TRANS/WP.29/GRSP/2001/16/Rev1
23 November 2001

World Forum for Harmonisation of Vehicle Regulations (WP.29)

PROPOSAL FOR DRAFT 04 SERIES OF AMENDMENTS TO REGULATION No. 44
(Child restraints)

Transmitted by the Expert from France

Figure 0e : ISOFIX Top tether connector (hook type) dimensions

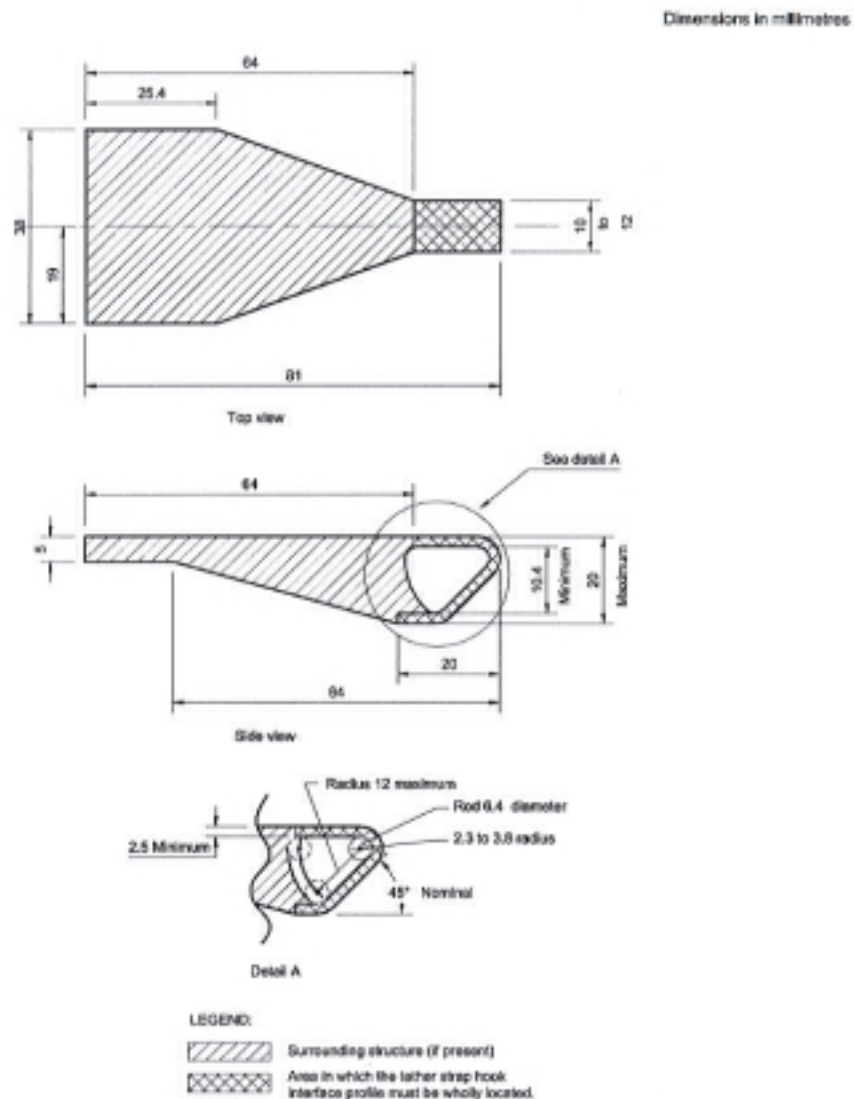
6.3.3.3.3. Dimensions

Engagement dimensions for ISOFIX top tether hooks are shown in Figure 0e.

Anchorage points H1 & H2 – 6 mm ± 0.1 mm

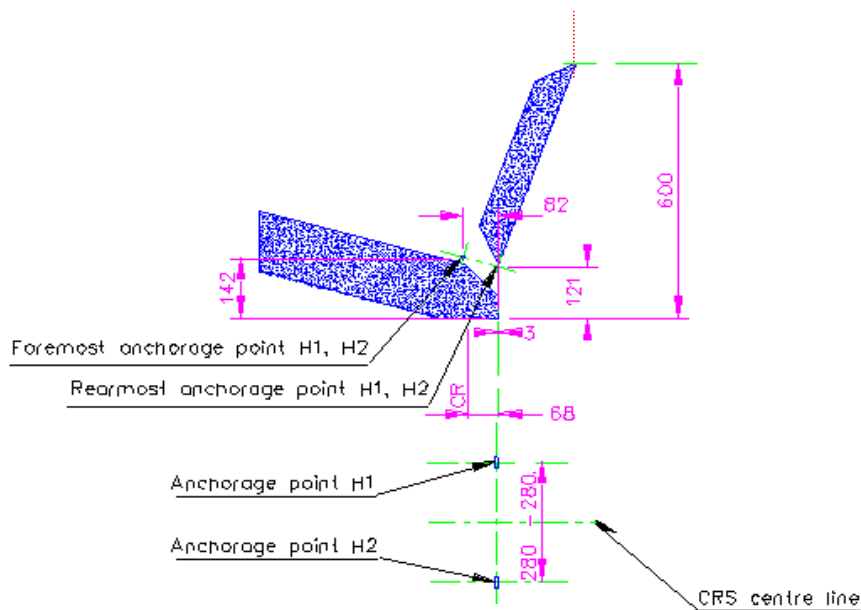
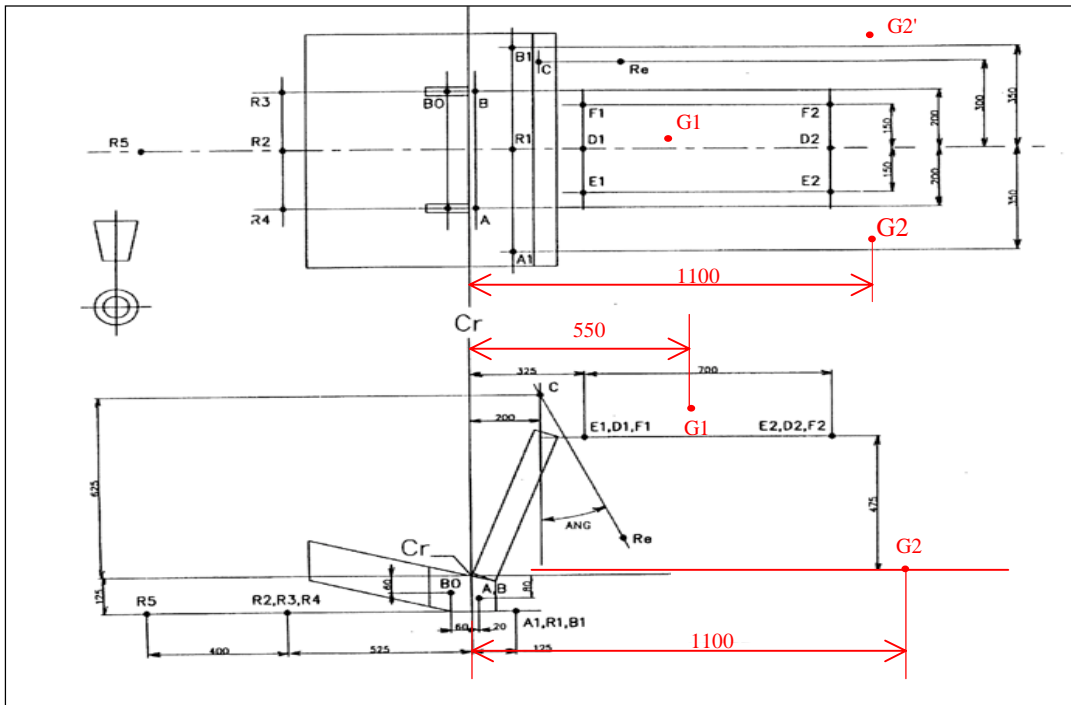
"1. The anchorages shall be positioned as shown in the figures 1,2 and 3 below."

"2.3. For child restraints using ISOFIX attachment, points H₁ and H₂."

Insert new figures, to read:

Annex 21,

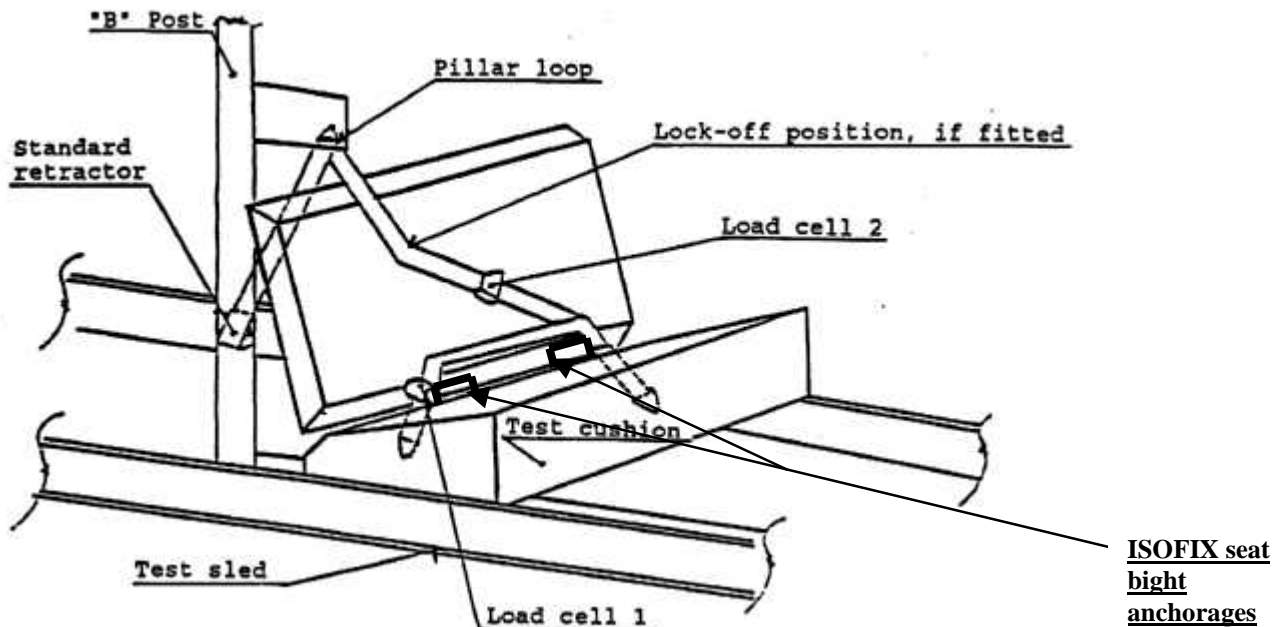
The figure, amend to read:
